修訂項目	日期	繪圖	核對	負責	說明
REV	DATE	BY	SUB	APP	DESCRIPTION
修訂項目 A23 至 A26 及 A28 修訂位置圖 LOCATION PLAN AMENDED	11 JUN 2010	MKC	CH	PP

圖則名稱 DRAWING TITLE
**鐵路條例(第519章)
- 觀塘線延線
收回土地圖則 2頁的第2頁**
RAILWAYS ORDINANCE (CHAPTER 519)
- KWUN TONG LINE EXTENSION
LAND RESUMPTION PLAN SHEET 2 OF 2

圖號 DRAWING NO. KTE-L02
比例 SCALE 1:500 (A1)
或如顯示
OR AS SHOWN

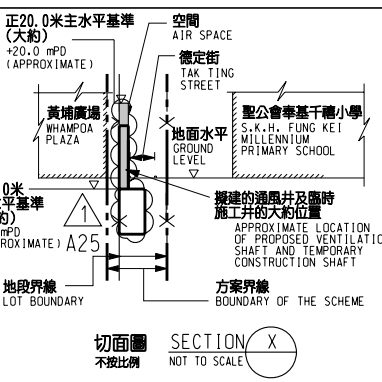
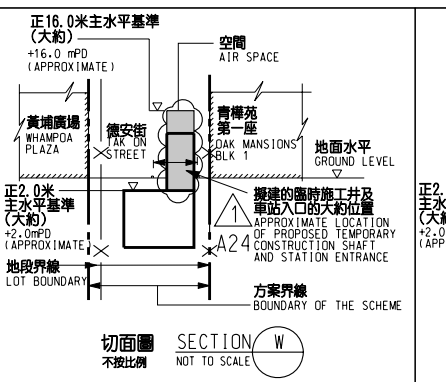
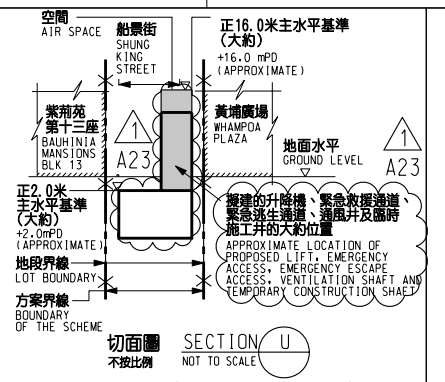
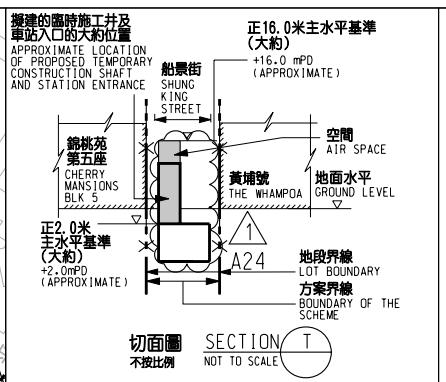
修訂擬建的升降機、緊急救援通道、緊急逃生通道、通風井及臨時施工井的布局及大約位置及修訂擬收回土地的範圍
LAYOUT AND APPROXIMATE LOCATION OF PROPOSED LIFT, EMERGENCY ACCESS, EMERGENCY ESCAPE ACCESS, VENTILATION SHAFT AND TEMPORARY CONSTRUCTION SHAFT AND SIZE OF PROPOSED LAND RESUMPTION AMENDED

無須收回的土地、刪除切面標記 V 及相關切面圖
LAND EXCLUDED FROM PROPOSED RESUMPTION, SECTION MARK V AND CORRESPONDING SECTION DELETED

修訂擬建的臨時施工井、車站入口的布局及大約位置及修訂擬收回土地的範圍
LAYOUT AND APPROXIMATE LOCATION OF PROPOSED TEMPORARY CONSTRUCTION SHAFT AND STATION ENTRANCE AND SIZE OF PROPOSED LAND RESUMPTION AMENDED

修訂擬建的臨時施工井及車站入口的布局及大約位置
LAYOUT AND APPROXIMATE LOCATION OF PROPOSED TEMPORARY CONSTRUCTION SHAFT AND STATION ENTRANCE AMENDED

修訂擬收回土地的範圍及切面標記 W
SIZE OF PROPOSED LAND RESUMPTION AND SECTION MARK W AMENDED

修訂擬建的通風井及臨時施工井的布局及大約位置及修訂擬收回土地的範圍
LAYOUT AND APPROXIMATE LOCATION OF PROPOSED VENTILATION SHAFTS AND TEMPORARY CONSTRUCTION SHAFTS, AND SIZE OF PROPOSED LAND RESUMPTION AMENDED

刪除擬建的緊急救援通道、通風井及臨時施工井
PROPOSED EMERGENCY ACCESS, VENTILATION SHAFT AND TEMPORARY CONSTRUCTION SHAFT DELETED

無須收回的土地、刪除切面標記 Y 及相關切面圖
LAND EXCLUDED FROM PROPOSED RESUMPTION, SECTION MARK Y AND CORRESPONDING SECTION DELETED

修訂方案界線
BOUNDARY OF THE SCHEME AMENDED
